Access Compliance Report

Public Rights-of-Way

| Intersection ID: 12482 | Main Street: SEAFORTH_DR | Cross Street: SUDBURY_RD | Location: SE |
| ADA ID: 617CEFB6DE63 | Ramp Type: Perp | Initial Pass/Fail: Fail | Overall Compliance: No |

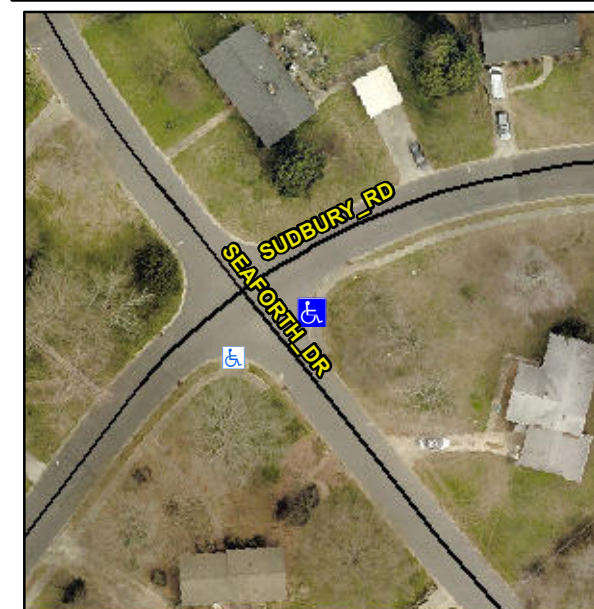
Remove & Replace Entire Ramp.

Not Found, R304.5.1

| Compliance | Description | Data | Compliance | Description | Data |
|------------|-----------------------|------|------------|-----------------------------|------|
| No | Ramp Width (in) | 44.5 | Yes | Ramp XSlope (%) | 1.1 |
